**CINTICHEM, INC.**

**SUBJECT:** Cintichem Response to NRC Request for Additional  
Information Regarding Decommissioning Plan - Cintichem,  
Inc.

This correspondence details our response to the above referenced  
NRC letter dated December 21, 1990.

FIG. 2A

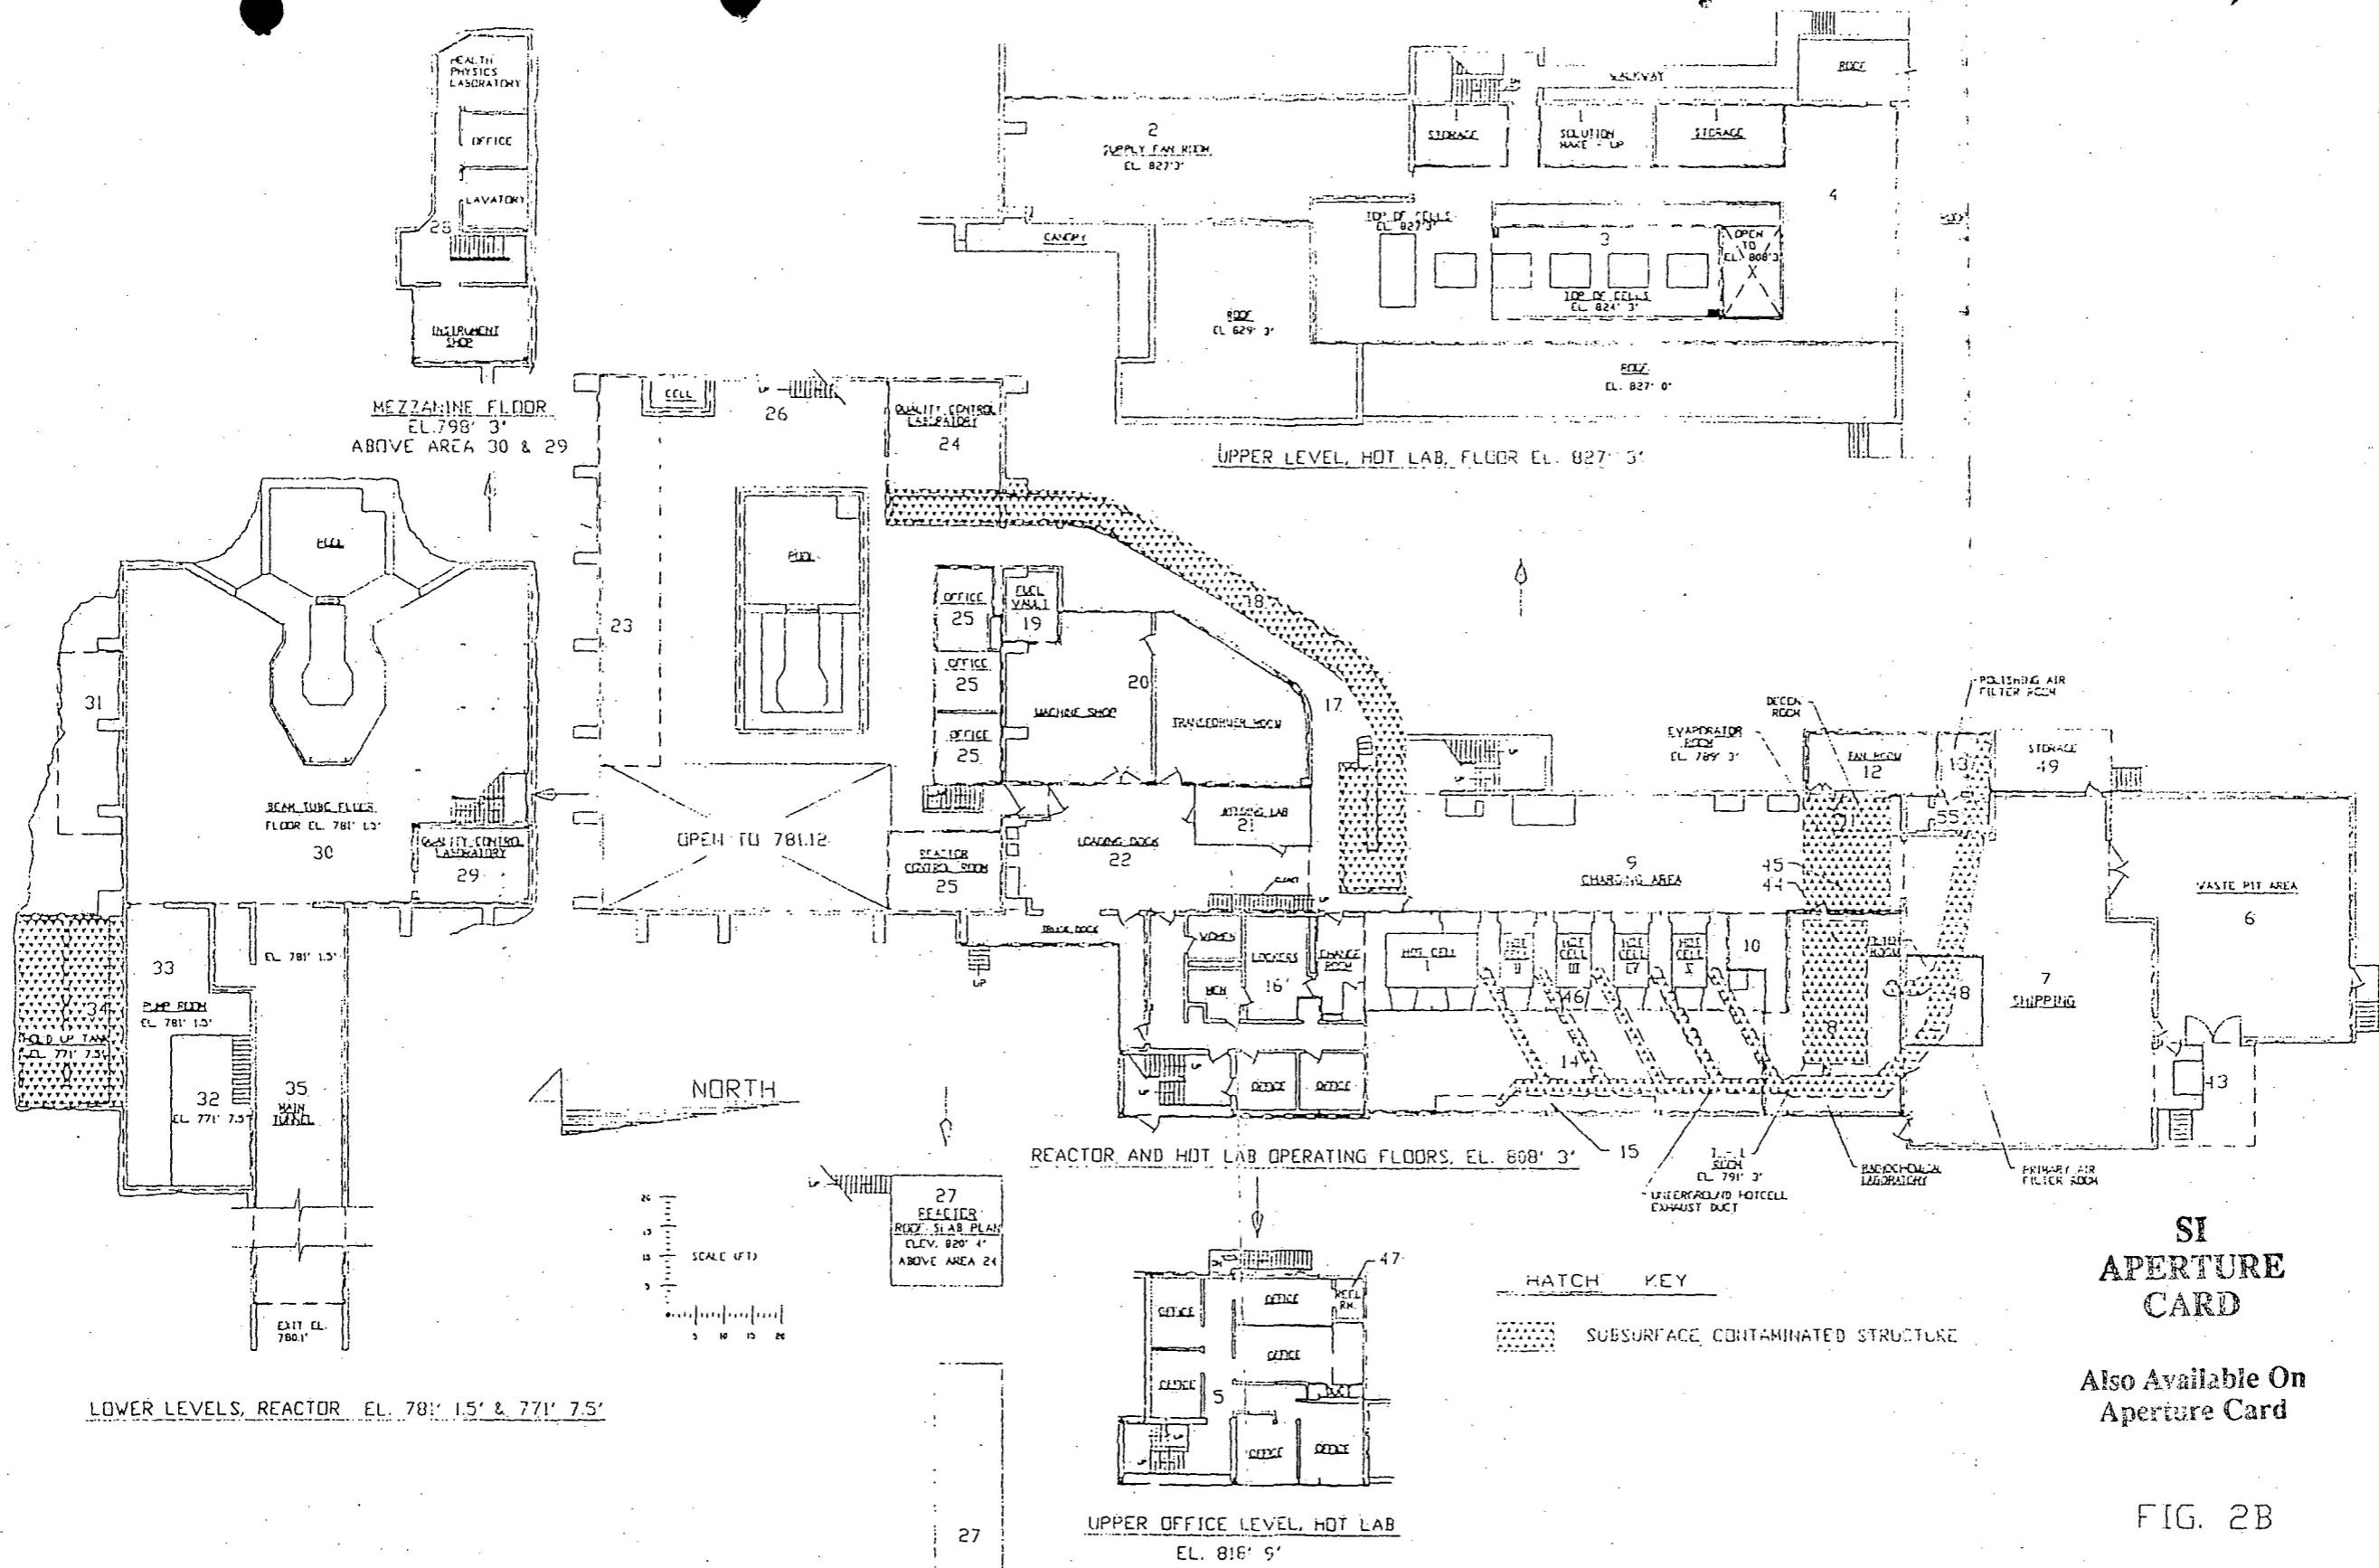
It is unclear from Section 1.3.5 where contamination was found and where it was not found. Provide such information. In addition, provide a layout indicating where subsurface contamination was found. Include with the layout an estimate of the volume of contaminated soil and the curie content of these volumes by isotope.

The location of structurally contaminated surfaces (floors, walls, structural steel, etc.) is shown on enclosed Figure 2a.
